# Berrima Gaol

## *Response to Submissions*

June 2026

Urbis has been engaged by Bluesox Group to prepare the following Response to Submissions (RTS) as part of our role as Heritage Consultant on the State Significant Development (SSD) Application SSD-66876472 for the Berrima Hotel.

Figure 3 – Elevation of Arbor

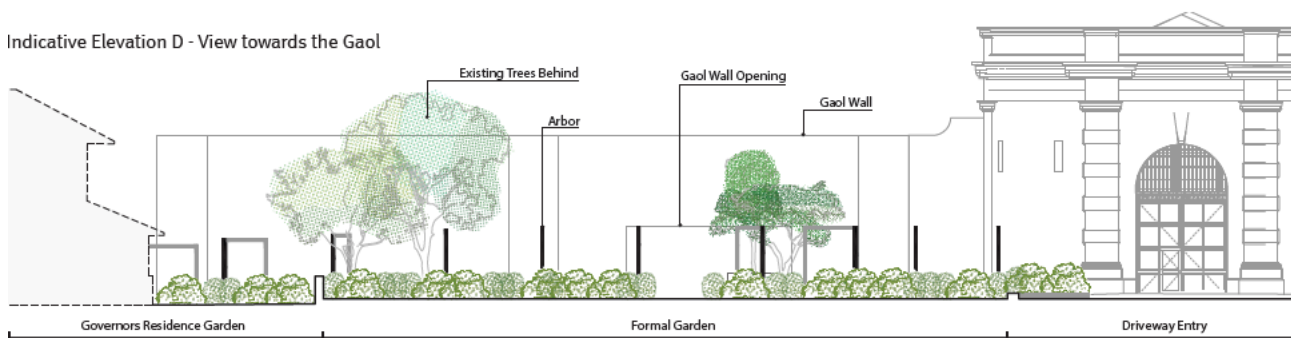
7. The landscape drawings show an arbor is proposed to be erected within the gaol's front garden close to the proposed new opening in the gaol wall. Please provide additional details of the arbor to illustrate its design and its visual permeability, noting that the new opening in the gaol wall is intended to increase permeability into the site. Please assess the heritage impacts of the proposed arbor.

The arbors are designed as lightweight, visually permeable elements that provide clear wayfinding for visitors approaching the site from the car park, guiding movement along the frontage towards the main entrance gate. Their open form and generous spacing allow views through to the gaol wall and ensure the structures do not dominate or detract from the wall's strong, solid presence. The selected height responds to the rusticated quoins of the 1866 Entrance Gate, establishing a datum that is informed by the historic fabric without replicating it.

The arbors are physically separated from all heritage fabric and will not result in any physical impact to the gaol wall or associated structures. Visually, their lightweight construction and spacing maintain permeability and views, resulting in a minor visual impact limited to views of the gaol wall. The proposed works are subservient to the wall and are consistent with Policy 48 of the Conservation Management Plan. They also comply with Policy 52 by maintaining appropriate setbacks, retaining key views, and preserving the legibility of the gaol wall.
